**Technical Service
BULLETIN**

DOOR WIND NOISE IMPROVEMENT

'01 – '05 Highlander

NV002-05

1. Replace Front Door Molding Assembly LH.

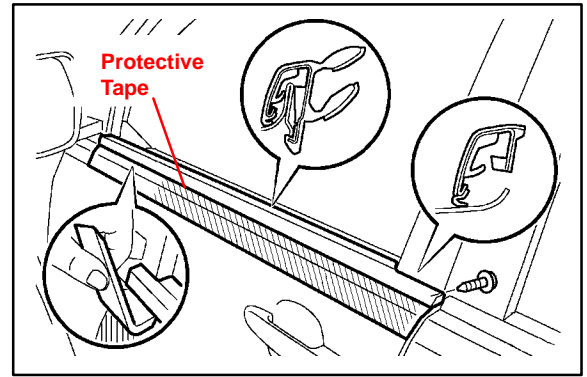
Introduction Some vehicles may exhibit wind noise coming from both the front and rear door window glass. The following repair has been developed to improve this condition.

Replace the affected outside belt molding assembly.

- A. Remove power window regulator switch assembly.
- B. Remove front door lower frame bracket garnish LH.
- C. Remove door pull handle.
- D. Remove front door trim board sub-assembly.

- E. Remove front door belt molding assembly LH.
 - a. Remove the screw.
 - b. Put protective tape under the molding (i.e., masking tape, body shop tape).
 - c. Using a molding remover or scraper, remove the molding.
